STAFF RECOMMENDATION

REZONING MASTER PLAN GOETTLE SPECIAL SERVICES COMPANY

SHEET 25064

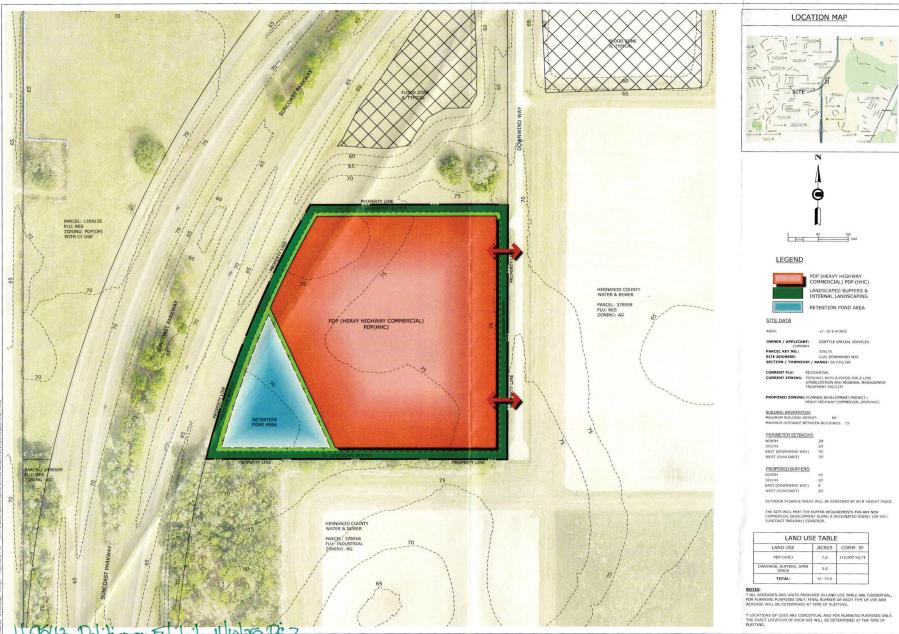
As the property adjacent to the east of this site is zoned AG (Agricultural) the minimum buffer shall be 20'. If the master plan is approved, the petitioner shall be

required to provide the following buffers:

North: 10' Natural vegetative buffer South: 10' Natural vegetative buffer

East (Downwind Way): 20-5' Natural vegetative Landscape buffer West (Suncoast Parkway): 20' Natural vegetative Landscape buffer

All buffers shall be enhanced as necessary to meet the minimum 80% opacity criteria. The outdoor storage area shall have an 8' opaque fence interior to the landscaping.
